Subject: Issuance of Amendment No. 11 to Facility Operating License
NPF-9 - McGuire Nuclear Station, Unit 1

AMENDMENT TO FACILITY OPERATING LICENSE

Amendment No. 11
License No. NPF-9

ATTACHMENT TO LICENSE AMENDMENT NO. 11

FIGURE 3.23 RCS TOTAL FLOWRATE VERSUS R_1 AND R_2 —FOUR LOOPS IN OPERATION

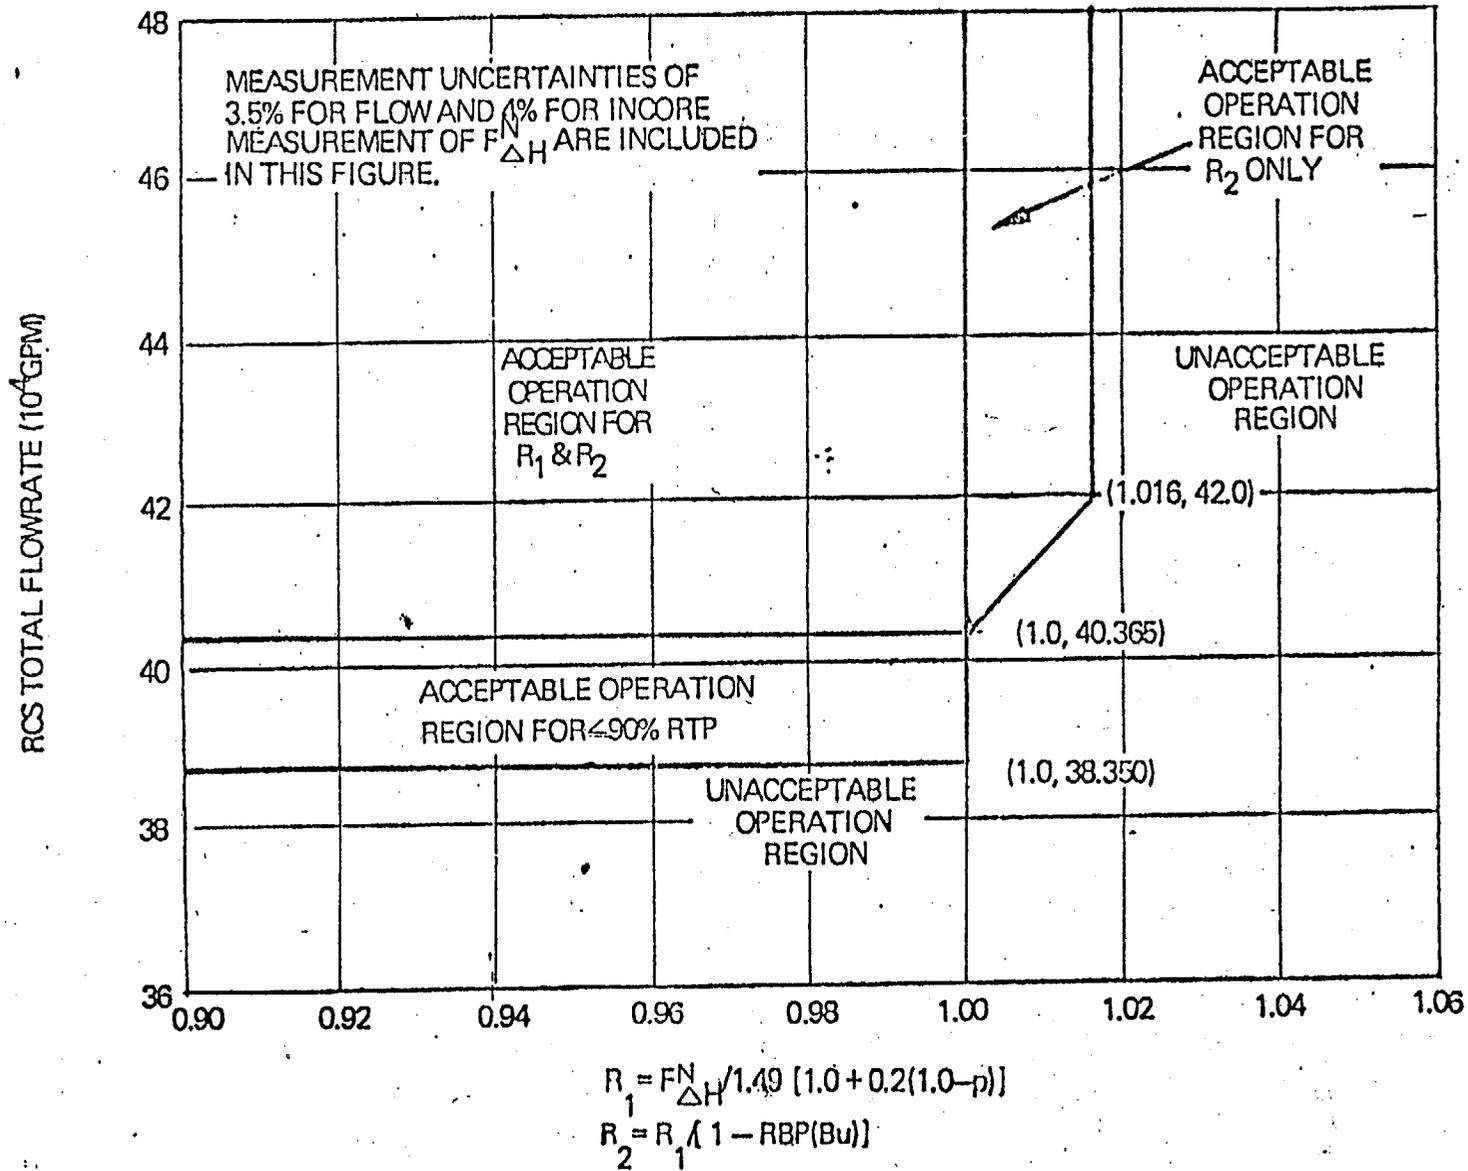
Operation above 90% rated thermal power may proceed for no more than 48 cumulative hours provided RCS total flow as measured by precision heat balance is greater than 395,850 gpm.

By letter dated January 4, 1982, the licensee requested a change to the McGuire Nuclear Station Unit 1, License NPF-9, Technical Specification 3.2.3, RCS Flowrate and Nuclear Enthalpy Rise Hot Channel Factor. The proposed one time change would add a note to Figure 3.2-3 to state:

"Operation above 90% Rated Thermal Power (RTP) may proceed for no more than 48 cumulative hours provided RCS total flow as measured by precision heat balance is greater than 395,850 gpm."

The current technical specification requires that the combination of the indicated reactor coolant system (RCS) flow rate, power and the measured F value be within the allowable operating ranges shown in Figure 3.2-3 of the technical specification for 4 loop operation. Figure 3.2-3 was established by including 3.5% of flow measurement uncertainty and, therefore, requires, for 100% power operation, a minimum RCS flow of 403,650 gpm which is 3.5% above the thermal design flow (TDF) of 390,000 gpm. The 3.5% uncertainty allowance is designed to permit surveillance requirements to be accomplished utilizing the control board indication for RCS flow rate. During the full power verification test, the flow rate is measured by a precision heat balance. The uncertainty of this calorimetric flow measurement is 1.5% for 4 loop operation as indicated in attachment 1A of the licensee's January 4, 1982 letter. Therefore, to maintain the TDF of 390,000 gpm, the minimum calorimeter measured flow rate requirement would be 395,850 gpm. This flow requirement will be followed during the full power verification test which will last no more than 48 cumulative hours. Based on our review, we conclude that the requested technical specification change does not result in a reduction in safety and is acceptable.
